**Subject: Response to Comments – Remedial Action Work Plan Addendum 1
Former Emerson Power Transmission Facility, Ithaca, New York**

REMEDIAL ACTION WORK PLAN ADDENDUM 1 REVISION 1

FORMER EMERSON POWER TRANSMISSION
ITHACA, NEW YORK (NYSDEC SITE NO. 755010)

RETAINING WALL SUMP REROUTING SECTION AND DETAILS
SLEEP REROUTING DESIGN
FORMER EMERSON POWER TRANSMISSION
ITHACA, NEW YORK
 PREPARED FOR
EMERSON – ST. LOUIS, MISSOURI

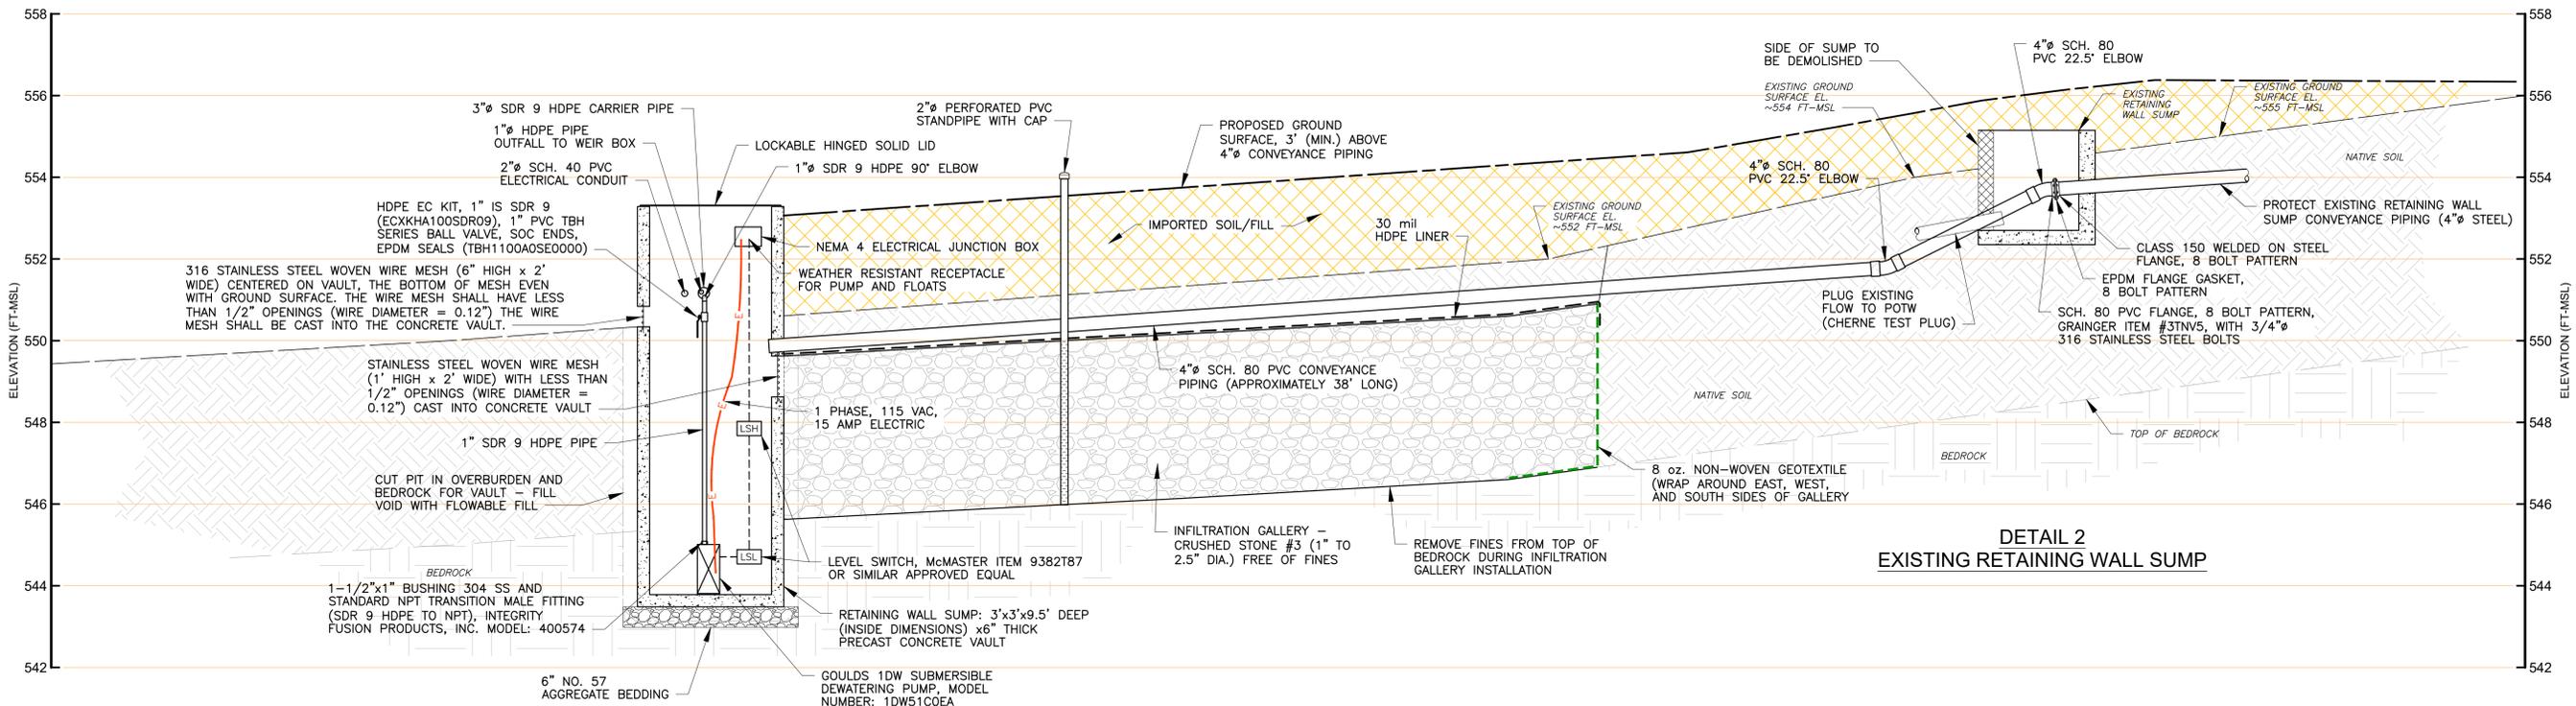
2 Section 5.2 Retaining Wall Sump Rerouting Design: Paragraph 9 states that the infiltration gallery will be sized to allow 24 hours of capacity in the event of a pump failure. The pump station must be equipped with a high-level alarm integrated with DPE system control panel such that pump repairs can be made expeditiously to avoid lengthy discharge to the bedrock surface. This modification must be included in the work plan. Additionally, revisions to the Operation and Maintenance Plan must include routine cleanout of the sump and its components in order to avoid fouling.

WSP plans to have the selected contractor's electrician evaluate alternatives for wireless high level controls with remote notification in lieu of hard-wiring a sensor to the system control panel; however, WSP believes that this additional control may not be warranted because the water discharging to the retaining wall sump does not currently exceed applicable groundwater standards. As summarized in Table 1 of the RAWP Addendum 1, the results of eight monthly samples (September 2023 through April 2024) collected from the Retaining Wall Sump after approval of the Pre-Design Study

report did not exceed Ambient Water Quality Standards or the SPDES Permit Equivalent standards for site-related volatile organic compounds. However, rerouting of the retaining wall sump water to the drainage structure is still being performed to remove the connection to the municipal sanitary sewer system.

The primary contingency for pump or power failure is the infiltration gallery. The 24-hour capacity of the infiltration gallery cited in the addendum was estimated based on dimensions (20 feet by 5 feet, by 4 feet deep), the porosity of the stone backfill, and a conservative inflow estimate of 1 gallon per minute. The 24-hour capacity also conservatively assumes no immediate infiltration vertically into the bedrock surface or horizontally to the surrounding soils. Therefore, if a wireless sensor with remote notification capabilities is not a viable alternative for this application, WSP requests approval to perform a field infiltration study to determine the likelihood of the infiltration gallery overflowing to the adjacent drainage ditch.

The field study would involve system installation as currently designed, but with a standpipe installed in the infiltration gallery to allow periodic measurement of the water levels during the study period. The discharge pump would be turned off to start the study. The pump station and standpipe will be monitored daily for a period of approximately 10 days to determine if the water infiltrates the bedrock formation faster than the rate of discharge from the sump (i.e, whether the pump station has the potential to overflow to the drainage ditch). While the measured flow rates during previous sampling events did not appear to correlate directly to precipitation, this study period may be extended to include precipitation events of various rainfall totals and intensities. After the study is completed, the pump will be reactivated to reroute the flow to the drainage structure as planned.

WSP is in agreement that the O&M Plan will be updated to include inspections and periodic cleaning of the pump station, pump, and controls to minimize fouling.
